Access Compliance Report

Public Rights-of-Way

(Curb Ramps)

Intersection ID: 48987	Main Street: ASHTON_GATE_DR	Cross Street: SMITHFIELD_DR	Location: SW
ADA ID: F596DC8E896E	Ramp Type: Perp	Initial Pass/Fail: Fail	Overall Compliance: No
Codes/Mitigation Info/Possible Solution		Field Measurements/Component Compliance	
Severity Score: 22.5

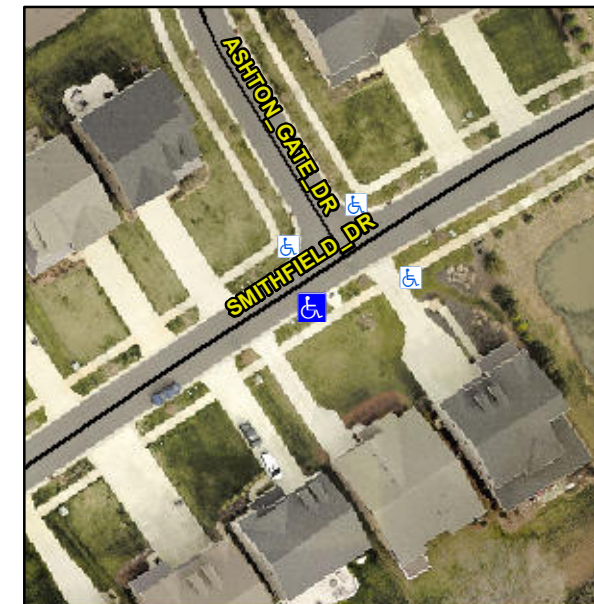
Not Found, R304.5.1, R304.2.2, R304.5.3

Compliance	Description	Data	Compliance	Description	Data
N/A	Ramp Length (in)	56.0	No	Ramp Slope (%)	8.5
No	Ramp Width (in)	47.5	No	Ramp XSlope (%)	3.5
N/A	Flare Type LT	N/A	N/A	Flare Type RT	N/A
N/A	Flare Slope LT (%)	N/A	N/A	Flare Slope RT (%)	N/A
N/A	Flare Traversable LT?	N/A	N/A	Flare Traversable RT?	N/A
N/A	Landing Length (in)	N/A	N/A	DWS Provided?	N/A
N/A	Landing Width (in)	N/A	N/A	DWS Contrast?	N/A
N/A	Landing Slope (%)	N/A	N/A	DWS Length (in)	N/A
N/A	Landing X Slope (%)	N/A	N/A	DWS Full Width?	N/A
N/A	Landing Curb? (Y/N)	N/A	N/A	DWS Offset (in)	N/A
N/A	Shared Landing?	N/A			
N/A	Gutter Ponding?	N/A	N/A	Gutter Slope (%)	N/A
N/A	Gutter Lip Ht (in)	N/A	N/A	Gutter X Slope (%)	N/A
N/A	Painted X Walk1?	No	N/A	Painted X Walk2?	N/A
	X Walk 1 Direction	To NW		X Walk 2 Direction	N/A
N/A	X Walk 1 Width (in)	N/A	N/A	X Walk 2 Width (in)	N/A
	X Walk 1 Slope (%)	4.8		X Walk 2 Slope (%)	N/A
	X Walk 1 X Slope (%)	1.8		X Walk 2 X Slope (%)	N/A

Remove & Replace Entire Ramp.
